October 18, 2012

**Re: Response to September 19 Technical Comment
Dewey-Burdock Project Groundwater Discharge Plan Application**

Dewey-Burdock Project

Figure 1

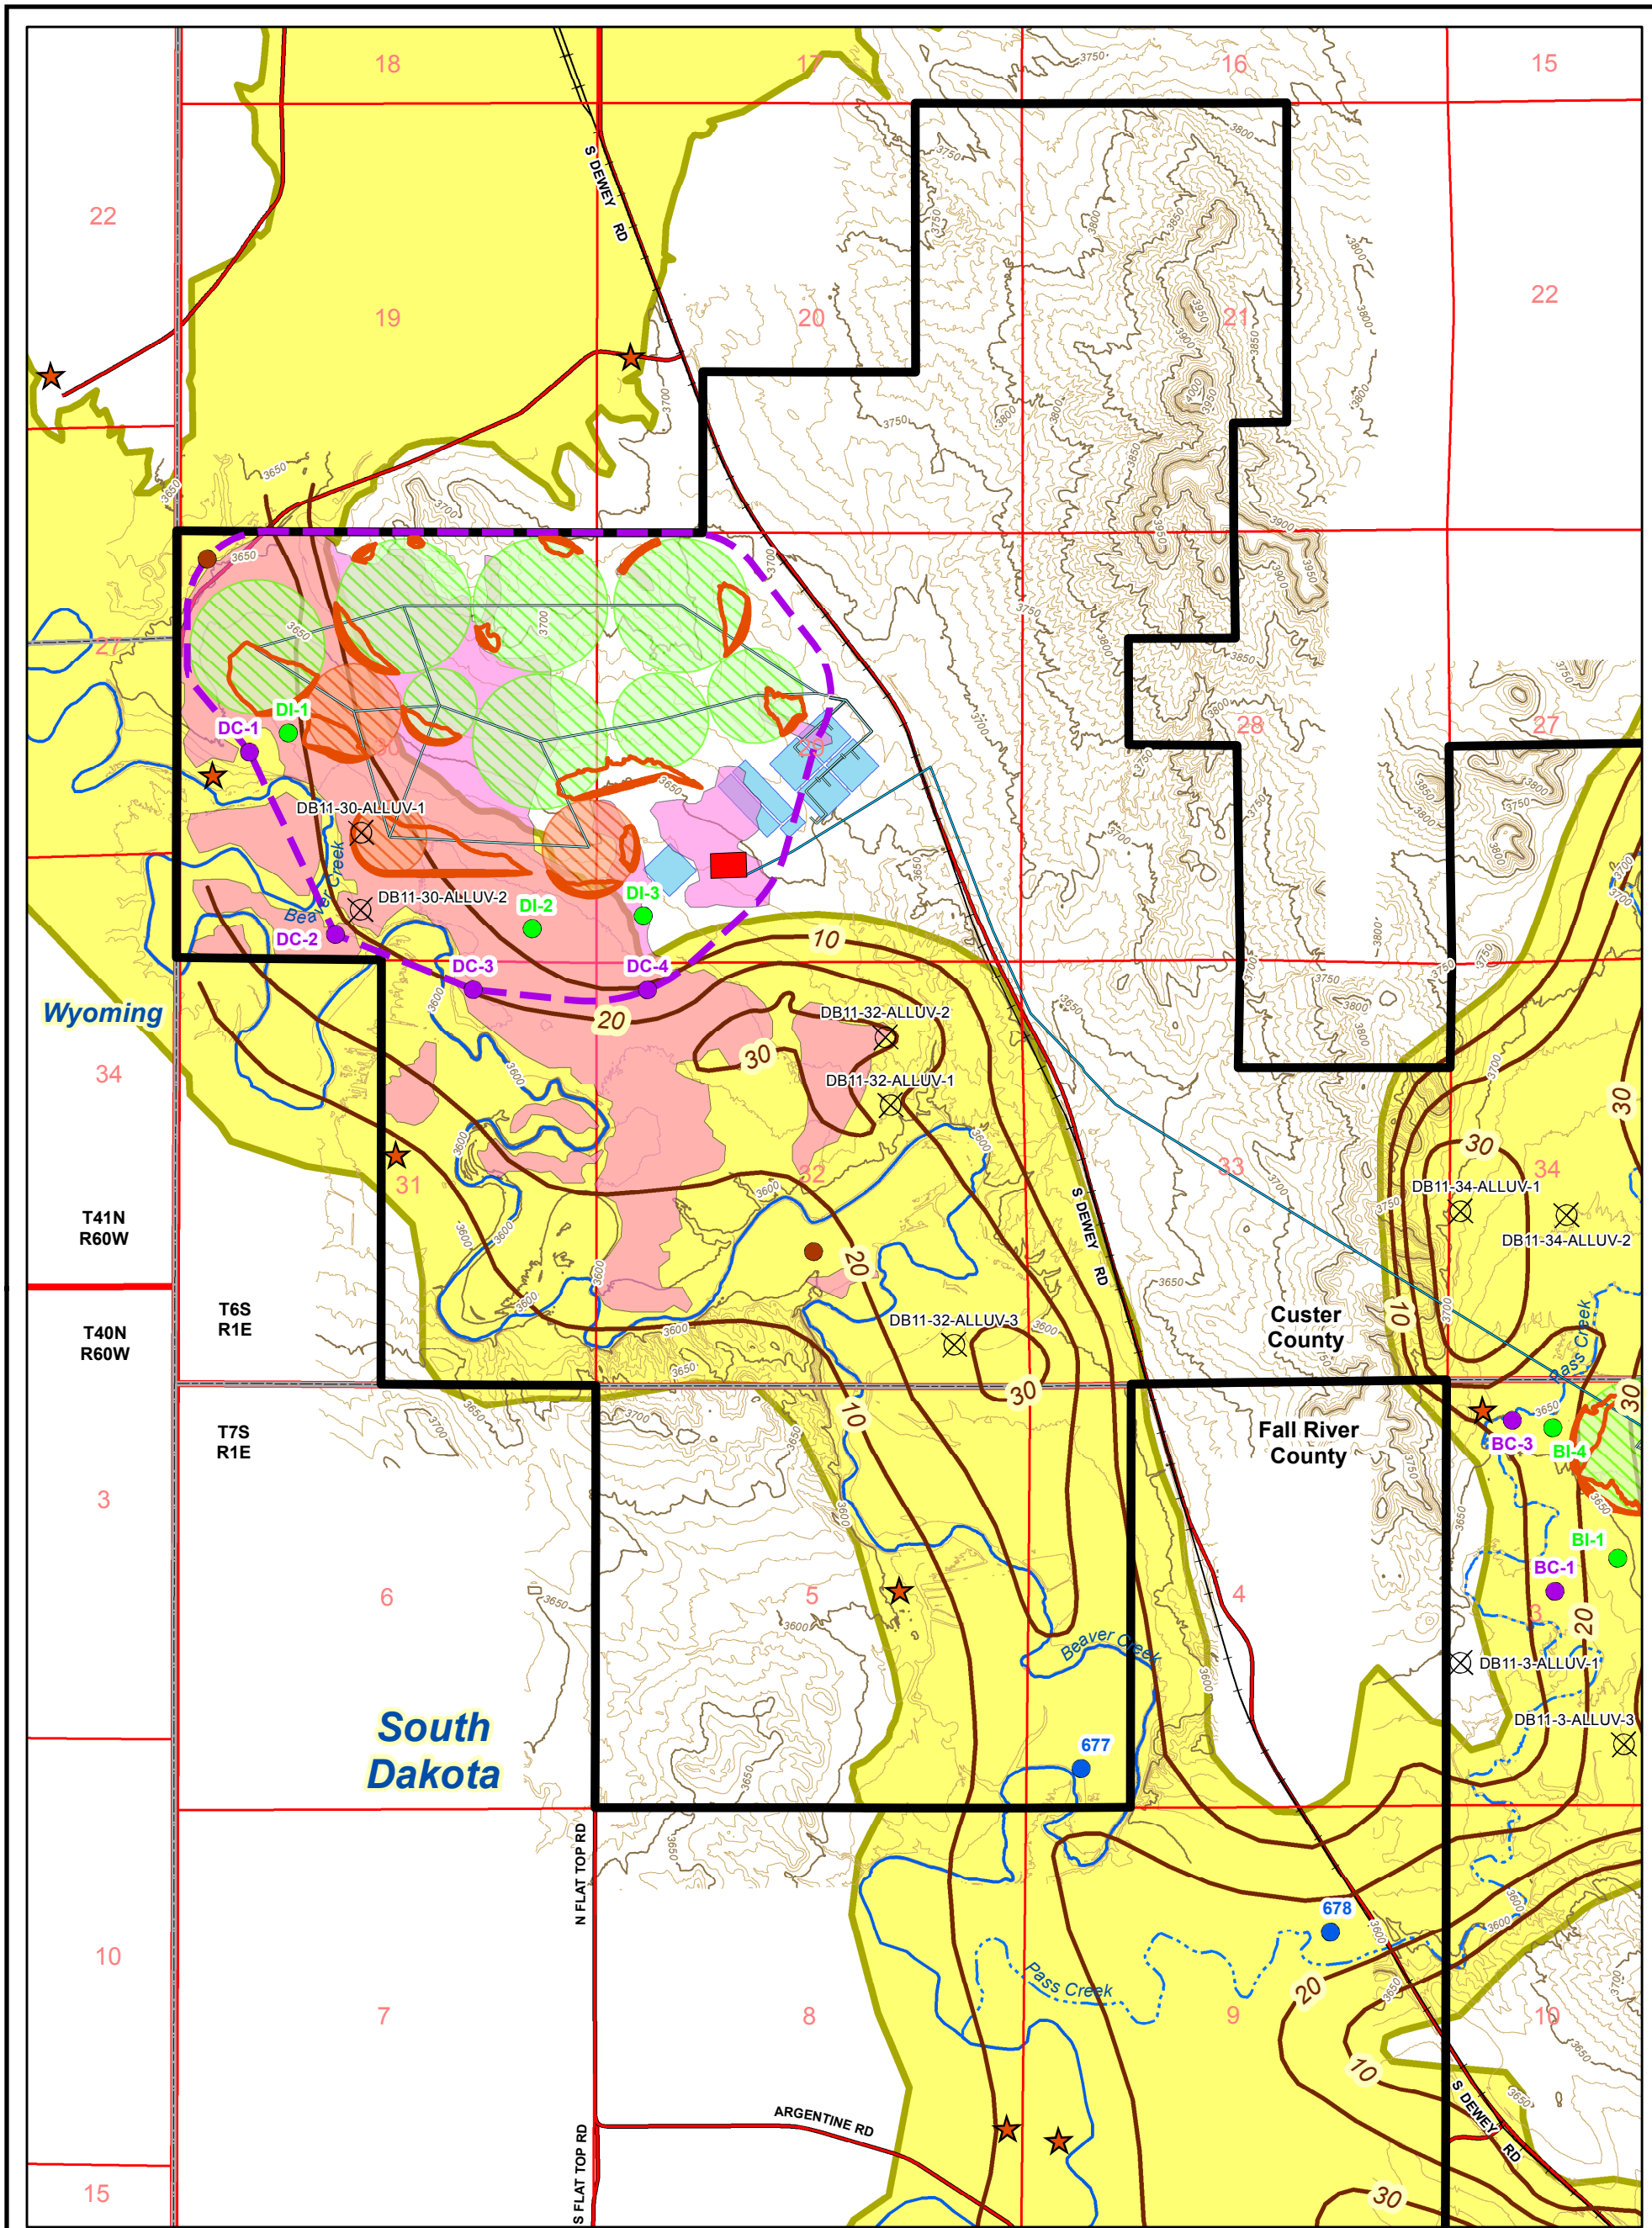
Technical Comment: Address whether prairie dog burrows have the potential to provide a pathway for land application effluent to reach groundwater or to transport land application solutions deeper into the soil column.

No prairie dog colonies are known to exist within the proposed Burdock land application or catchment areas. Figure 1 (enclosed) depicts the approximate extents of prairie dog colonies within the vicinity of the proposed Dewey land application and catchment areas. The approximate extents are based on high-resolution aerial imagery photographed in 2008 as part of the topographic survey of the project area and wildlife surveys conducted in 2007 and 2008. This figure shows that approximately 50% of the proposed Dewey land application and catchment areas coincide with prairie dog colonies.

Powertech assessed the density of burrow entrances within prairie dog colonies using the 2008 aerial imagery. Using ArcGIS, 1-acre squares were drawn at 12 randomly selected locations within the prairie dog colonies, and the density was determined by counting the number of

burrow entrances within each square. The density was found to range from 4 to 20 burrow entrances per acre, averaging approximately 10 burrow entrances per acre. The Montana Field Guide for the Black-Tailed Prairie Dog (Montana, 2012) indicates that burrow density varies substantially, with a typical range of 20 to 50 burrow entrances per acre. The average density in the project area is lower than this typical range.
